PREVOST

**WARRANTY
BULLETIN**

Wb97-18

DATE: October 1997	SECTION: 22
SUBJECT: FREON STICKERS REPLACEMENT

FIGURE 1: VEHICLE EXTERIOR

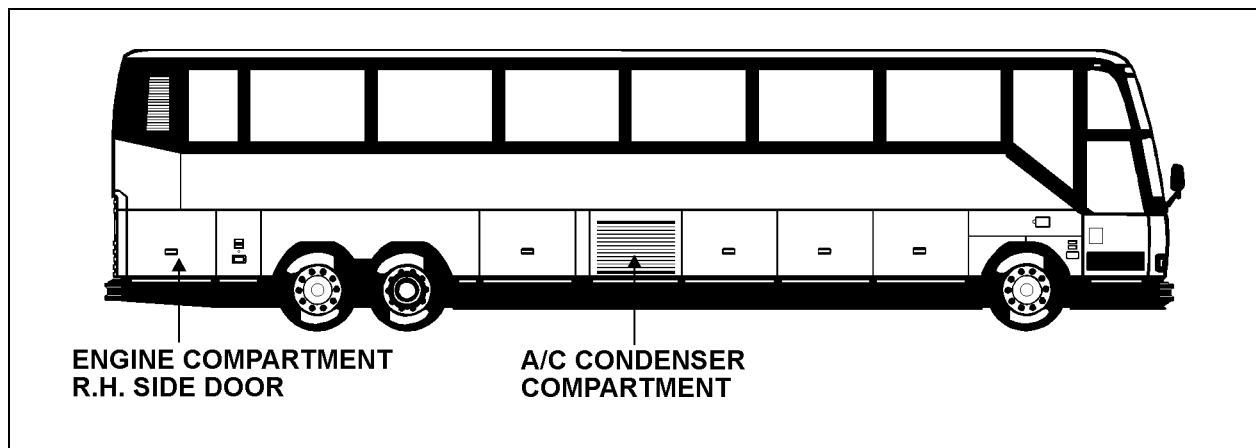
1. Replace freon sticker (Prévost # 453067) located inside engine compartment right hand side door with freon sticker (Prévost # 453101) (refer to fig. 1).

FIGURE 2: CONDENSER COMPARTMENT

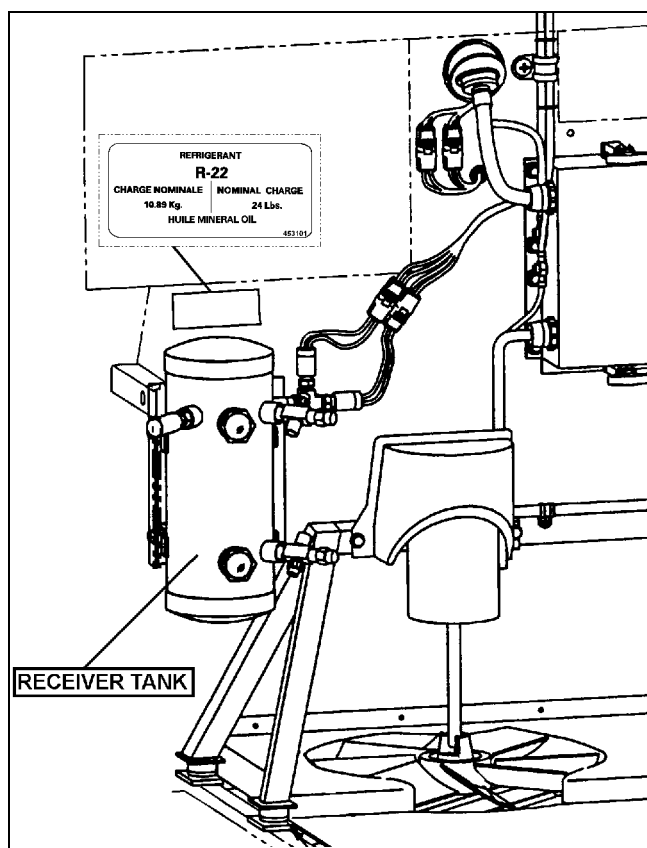
2. Replace freon sticker (Prévoist # 453067) located above receiver tank inside A/C condenser compartment with freon sticker (Prévoist # 453101) (refer to fig. 1 and 2).
